09 April 1996

**APPLICATION FOR SUBDIVISION CONSENT - RUTHERFORD
WESTBROOK PLACE**

PROPOSED SUBDIVISION OF LOT 9 DPS.27001
PREPARED FOR: D.G. RUTHERFORD

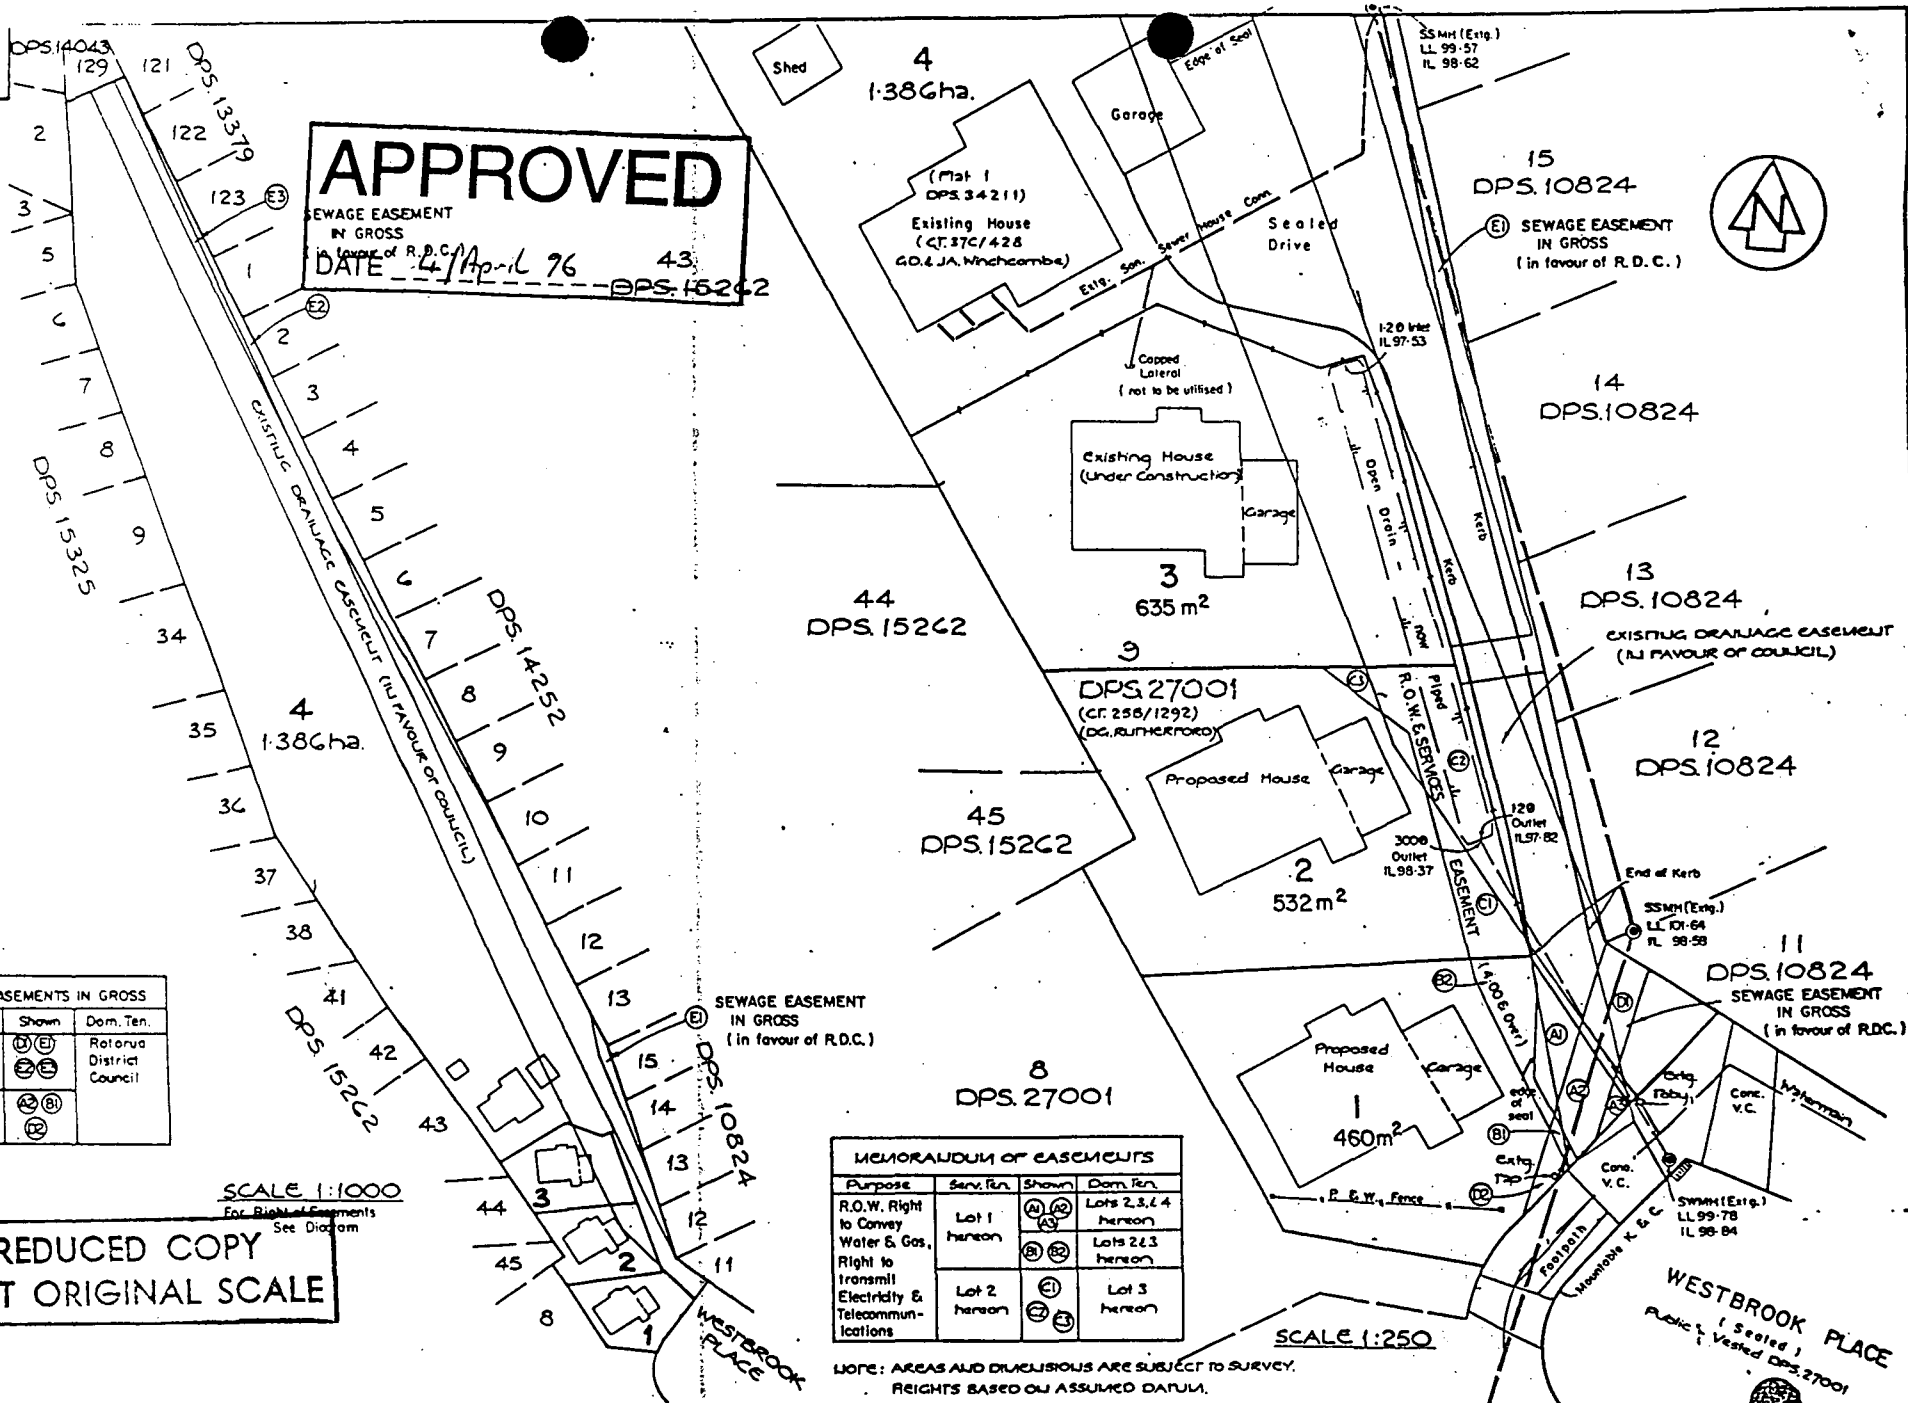
- ii) That engineering plans, calculations and specifications for the right of way and stormwater overland flow path in accordance with Council's Engineering Code of Practice are submitted to the District Engineer for approval, and such works are carried out to his satisfaction.

- iii) That the existing stormwater pipe and open drain crossing Lot 4 is protected by a drainage easement in favour of the Rotorua District Council.
- iv) That a surface stormwater secondary flow path crossing Lots 1, 2, 3 and 4 is designed and constructed to contain surface flows and is protected by an easement in accordance with Council's Engineering Code of Practice and District Plan.

- vi) That the rights of way serving Lots 1, 2 and 3 are laid off as shown on the plan and the same formed, constructed and drained in accordance with Council's Engineering Code of Practice and District Plan.

- viii) That Lots 1, 2 and 3 are each provided with a separate sanitary sewerage connection in accordance with Council's Engineering Code of Practice and District Plan.

- ix) That any sewerage laterals serving Lots 1, 2 and 3 and crossing Lot 4 are protected by sewerage easements in favour of the Rotorua District Council.

- x) That the redirected stormwater pipes and open drain crossing Lot 4 are investigated and upgraded where necessary to comply with Council's Engineering Code of Practice and District Plan .

- xi) That the redundant portion of the existing stormwater easement on Lot 4 is uplifted to the satisfaction of the District Engineer.
- xii) That all of the existing filling on Lots 1 and 2 is investigated by an engineer specialising in soil mechanics and the land certified in accordance with Council's Engineering Code of Practice and District Plan.

- xiii) That a Consent Notice be registered against the titles of the Lots 1 & 2 advising owners that no habitable buildings are to be erected on the proposed Lot 1 or 2 with a floor level of less than 300mm above a 50 year flood level.

- a) In granting this consent, Council resolves in terms of section 321(3)(c) of the Local Government Act 1974, that adequate access to Lot 1 and Lot 2 is provided by easement of ROW.
- b) The future development on Lot 4 will be restricted by the width of the proposed access leg.
